RE: Circle Court Parking Lot and Walkway Upgrade Project
Notice of Intent

GCG Associates, Inc., on behalf of the North Attleborough Housing Authority has updated our plans to reflect comments and discussion from the recent hearings. The following revisions have been made to the plans.

PARKING LOT & WALKWAY UPGRADES

CIRCLE COURT (667-1)

SITE PLAN - CIRCLE COURT

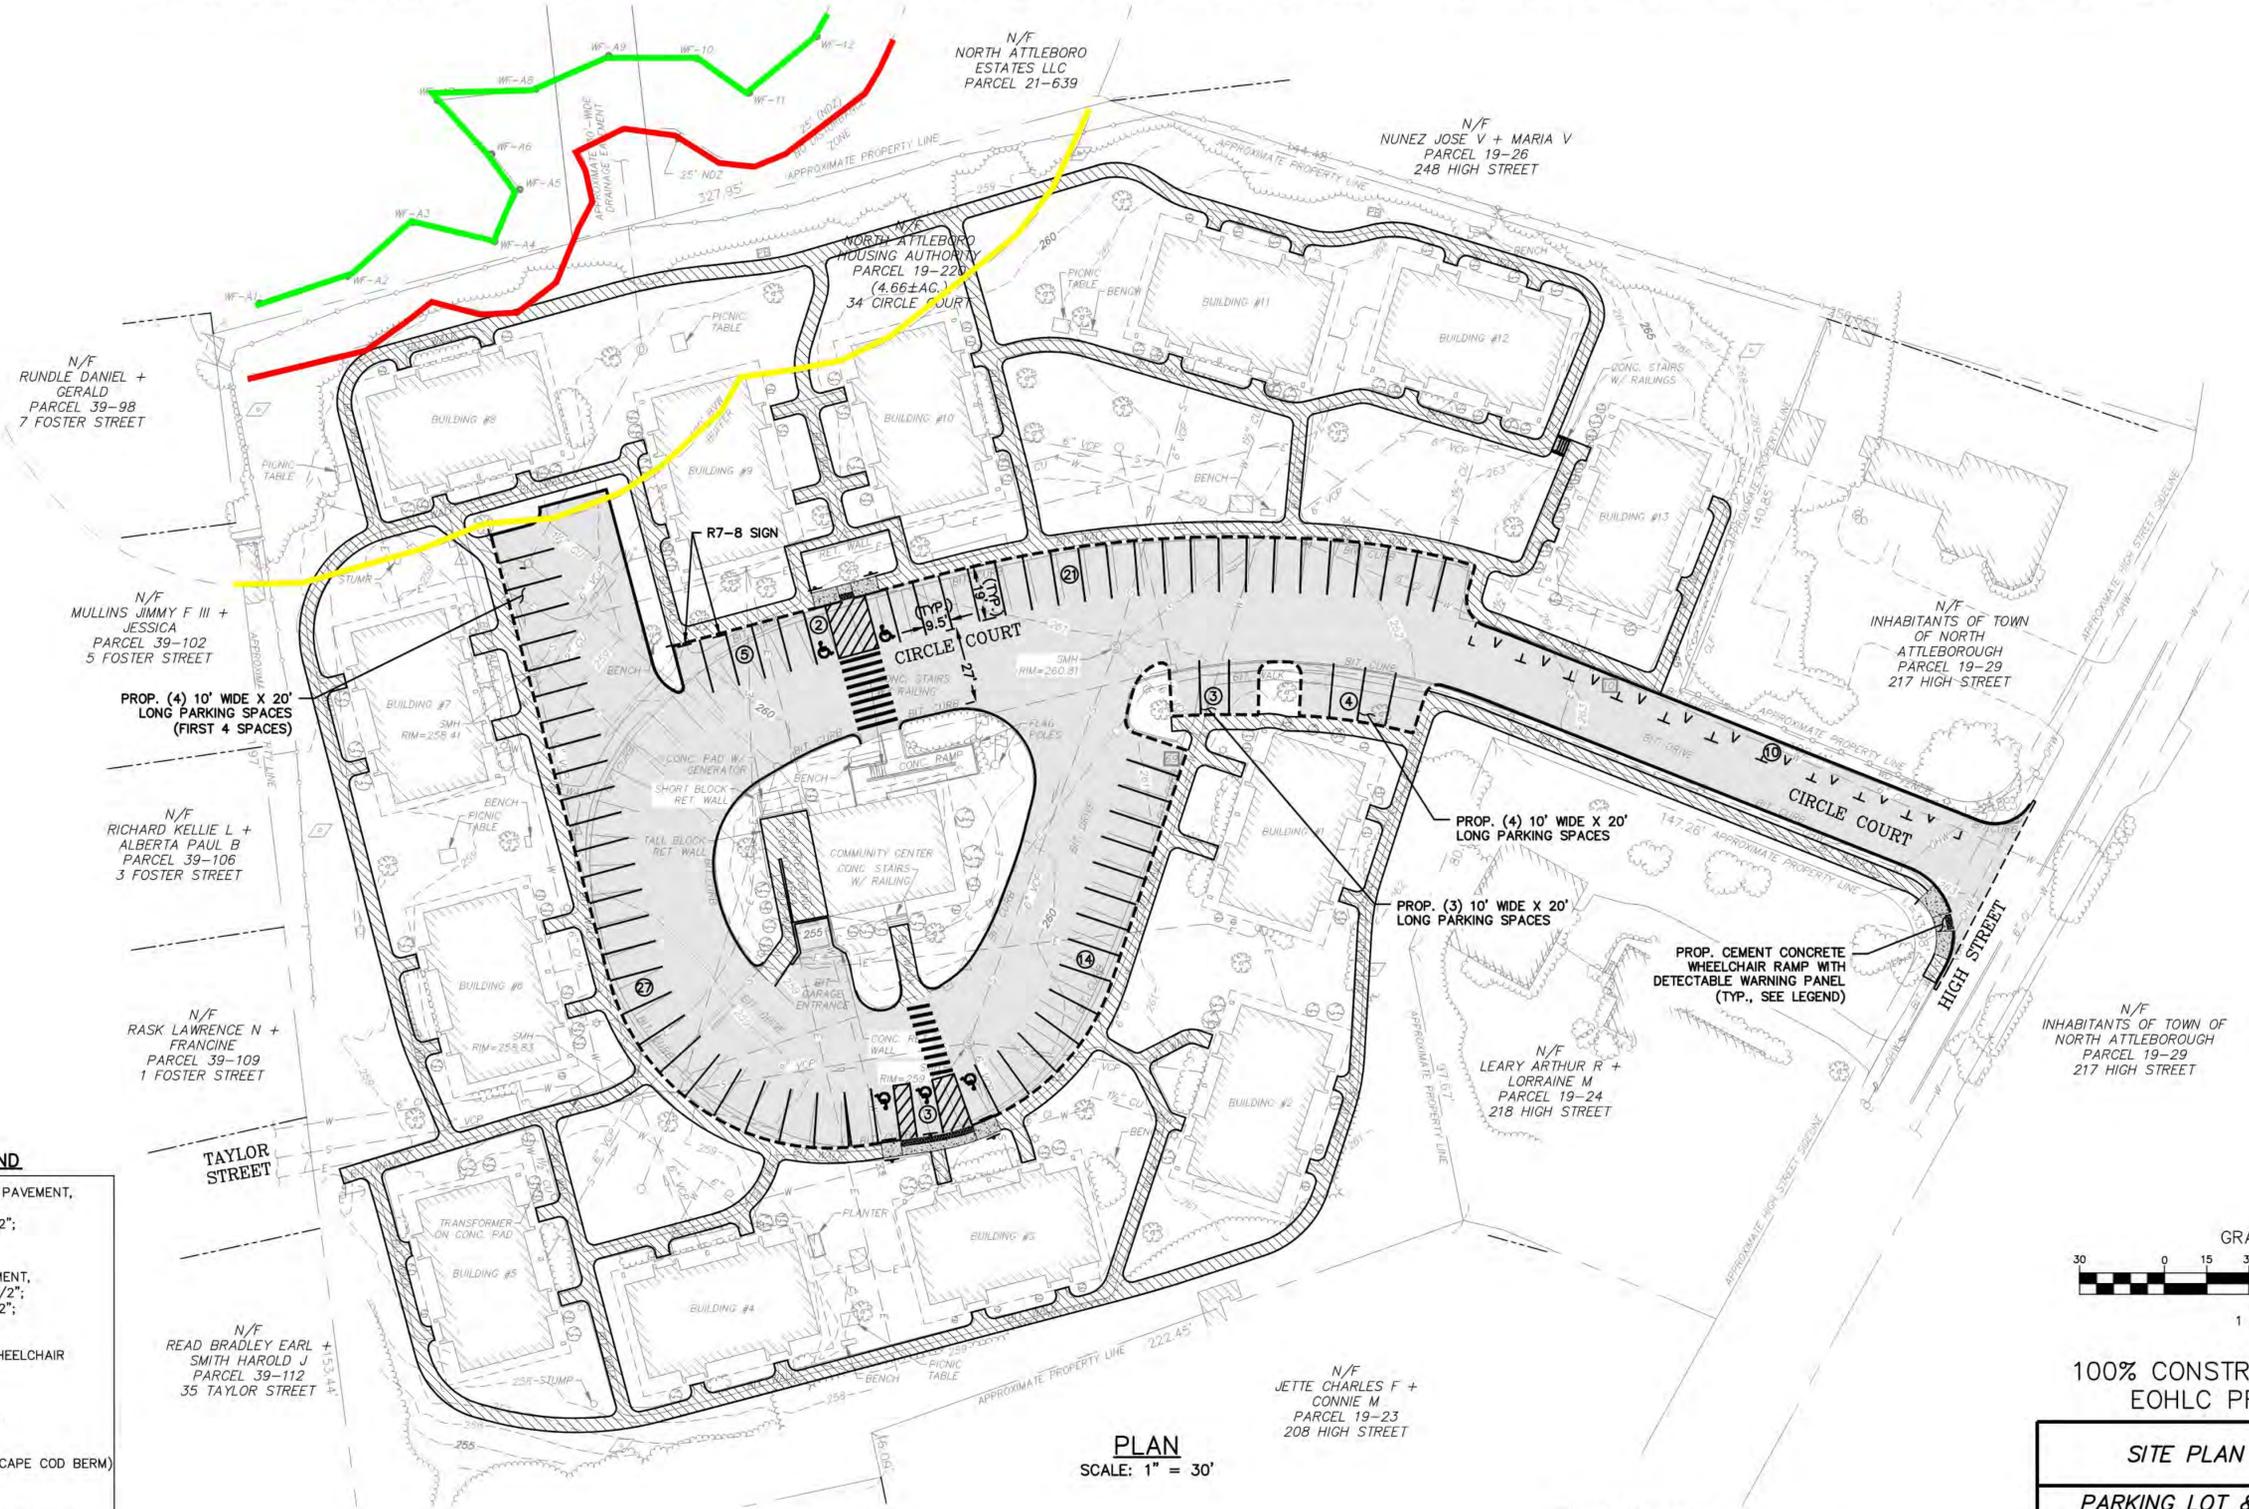
- The plans have been updated to include a stormwater treatment device for water quality on the existing 15" which discharges into the adjacent wetlands which we believe is a greater benefit to treat the stormwater instead of a 4-foot sump. The device will allow for additional treatment of all the onsite catch basins which connect to this drain. A Stormceptor detail has been added to the plans, and the location is shown on the site plan.

UTILITY SITE PLAN

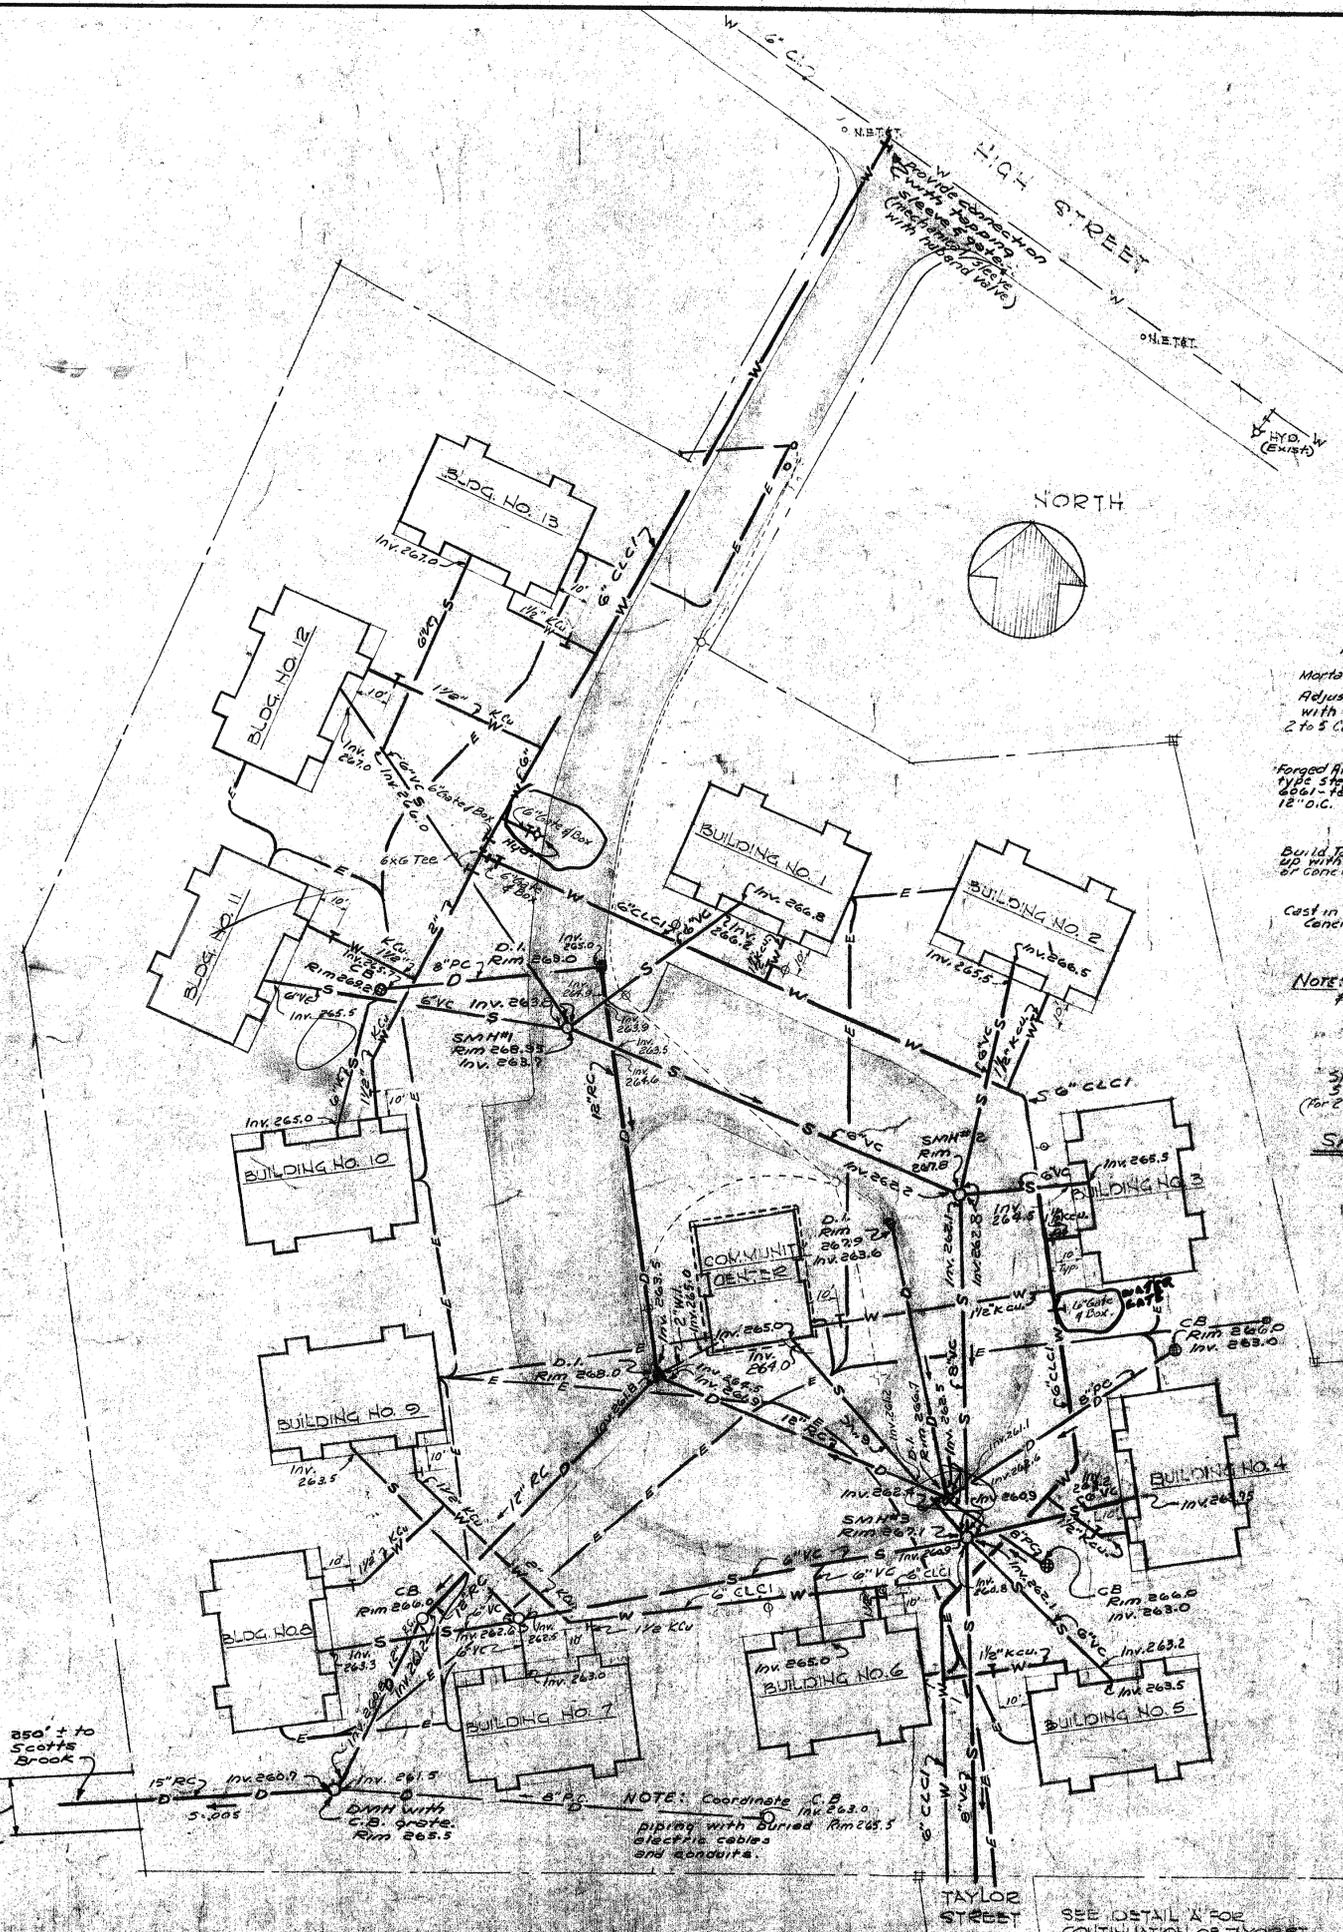
- GCG reviewed the original design plans for the development and has determined that the catch basins have a 3-foot sump. We have attached copies of the original plans which reflect this. The plans already required cleaning basin, jetting drain lines and CCTV drain lines. There are 8 catch basins located on the site. We considered removing and replacing them to install four-foot sumps. The cost to do this would be approximately \$64,000. The current project is funded through the Executive Office of Housing and Livable Communities and does not have additional funds to cover this cost. **The plans now include the installation of a hood in the existing catch basins to reduce sediment and oil from potentially flowing down the pipe.**
